**REDUNDANT INFLUENT LINE  
WASTEWATER TREATMENT PLANT  
BURLINGTON, IOWA**

**ADDENDUM NO.2**

February 1, 2024

SHEET NO.  
P101

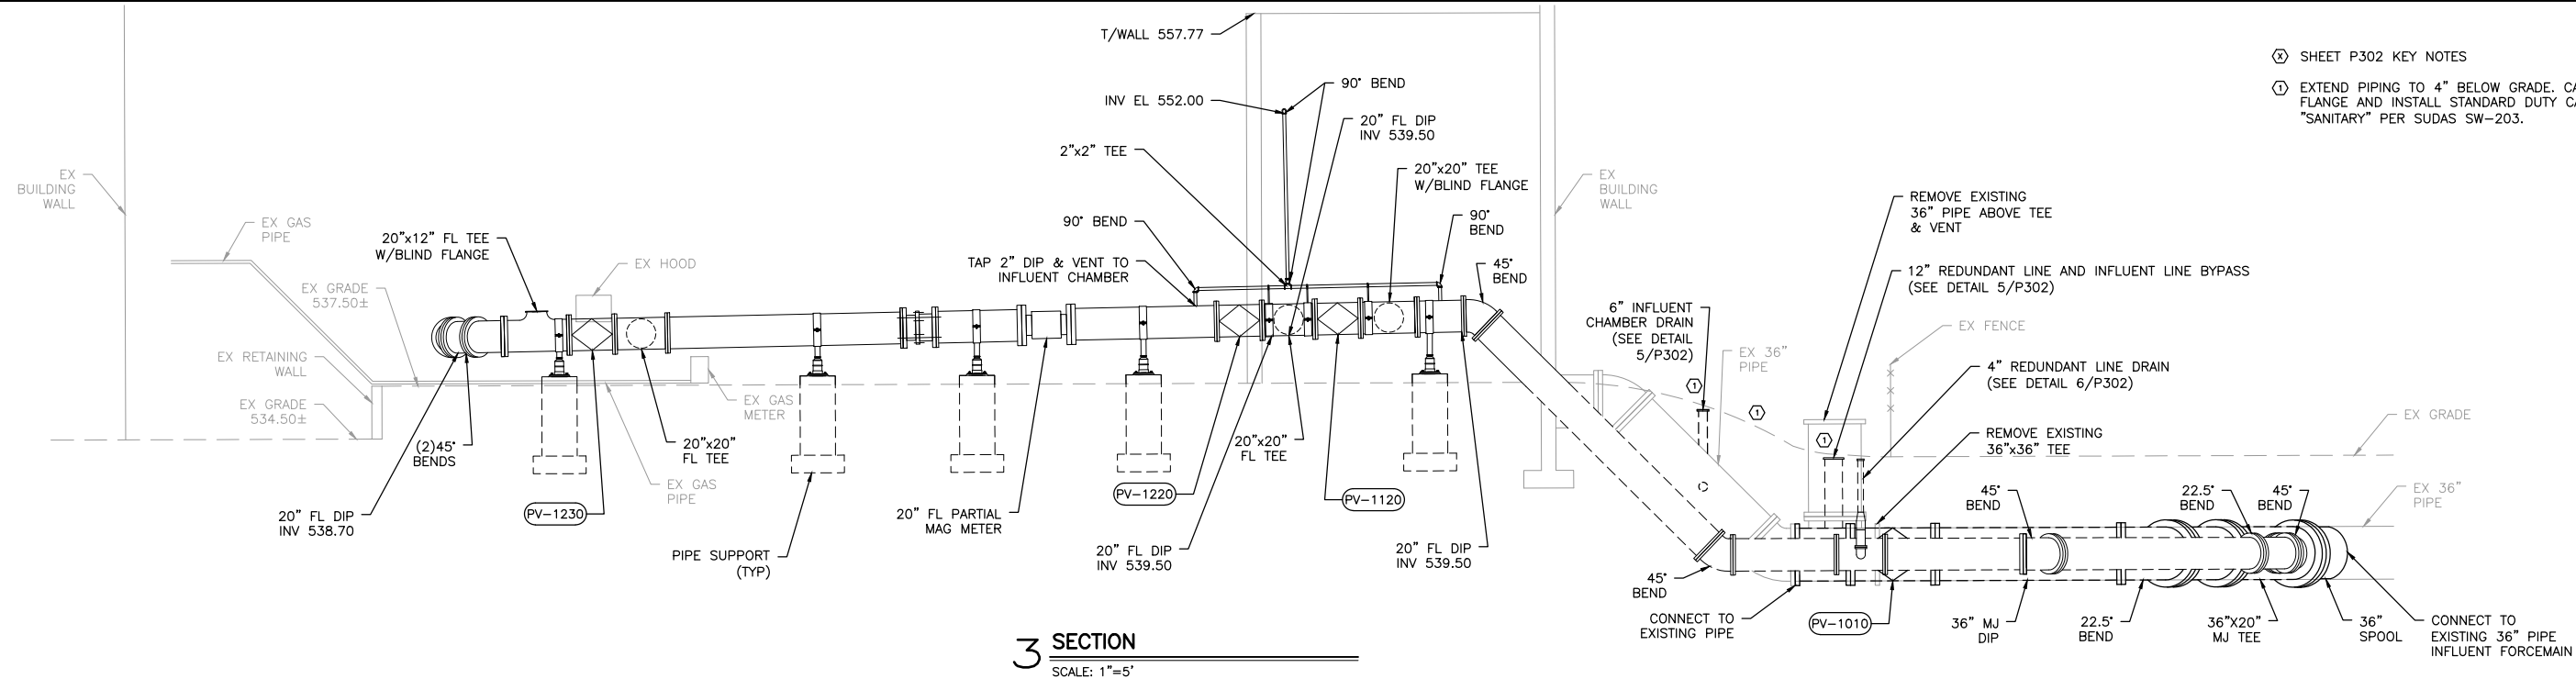
7. There shall be no buried dismantling joints. All buried dismantling joints have been removed from the project. Two (2) buried 36-inch DIP sleeves have been added. See revised **SHEET P101**(attached), revised **SHEET P302** (attached) and revised **SHEET P601** (attached) for changes. **SHEETS C101** and **C102** have not been updated to reflect these changes. The changes will be included on all plan sheets when the Conformed Construction Documents are issued to the Contractor after the project is awarded. The 20-inch DIP Flanged dismantling joint remains a part of the project. Summary of changes include the following:

- a. Replace the 36" dismantling joints with spool pieces.
  - b. Add two 36" sleeves.
  - c. Delete 20" DI MJ Dismantling Joint.
  - d. Delete 12" DI MJ Dismantling Joint.

- e. Delete 6" DI MJ Dismantling Joint.

SHEET NO.  
**P302**

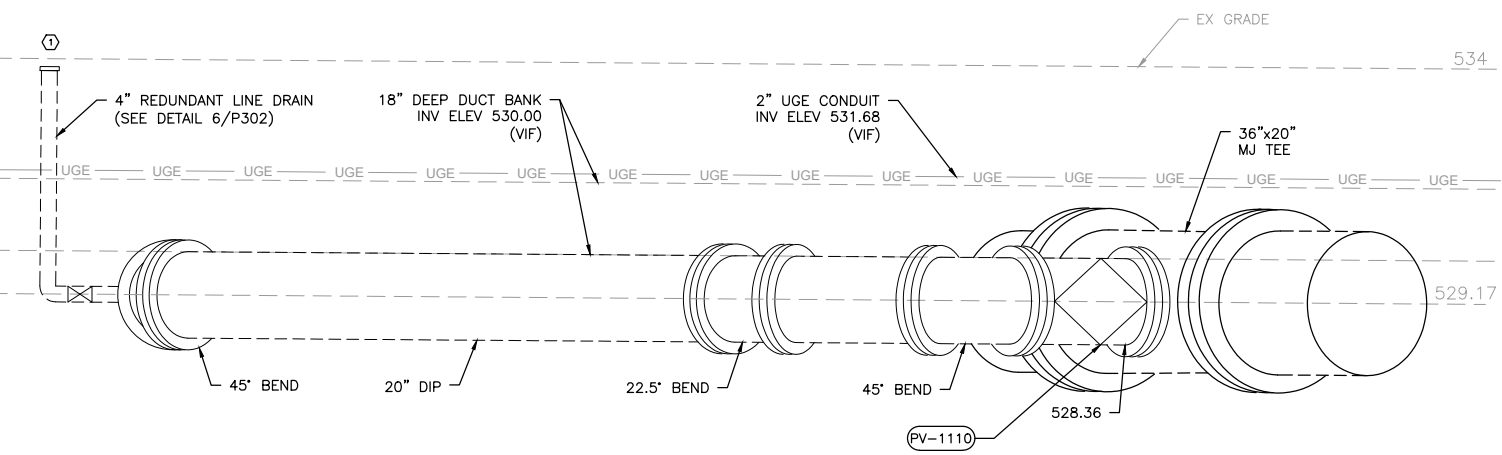
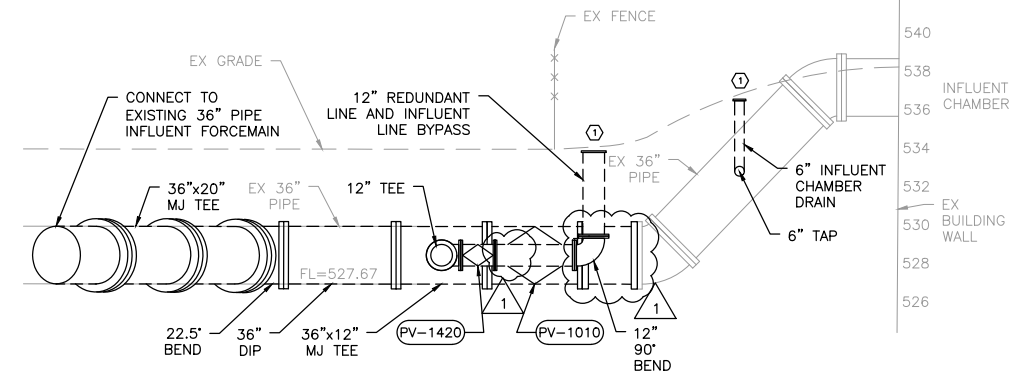
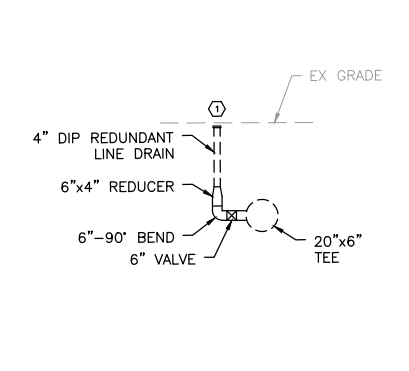
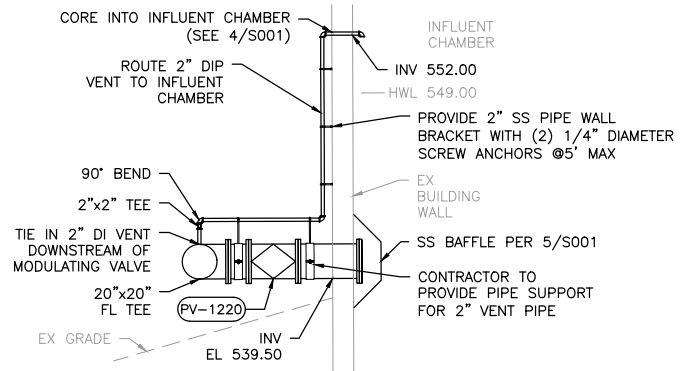
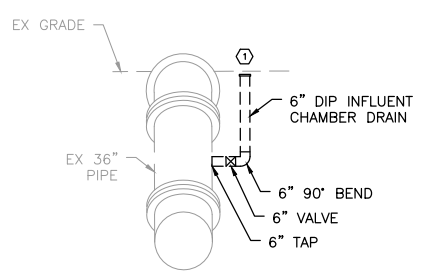
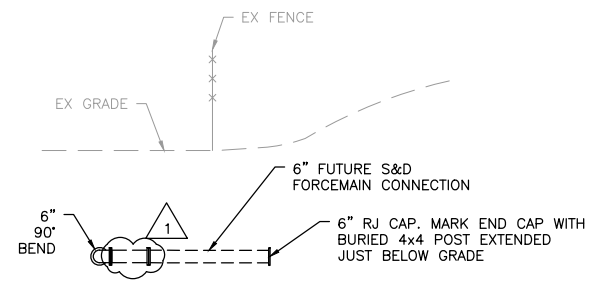
- c. **ADD** Item No. 4.19 Plug Valve, 36-inch D. “Dewatering/draining of influent 36-inch line shall be incidental to this bid item.”
3. **REFER TO SHEET P302, DETAIL 3**

- a. **REPLACE** 2-inch DIP and DIP fittings with 3-inch DIP and DIP fittings for the vent pipe
4. **SHEET S001, DETAIL 4**
  - a. Wall thickness for all wall penetrations is 1’-0”. Two (2) sets of mechanical seals shall be provided for each penetration.
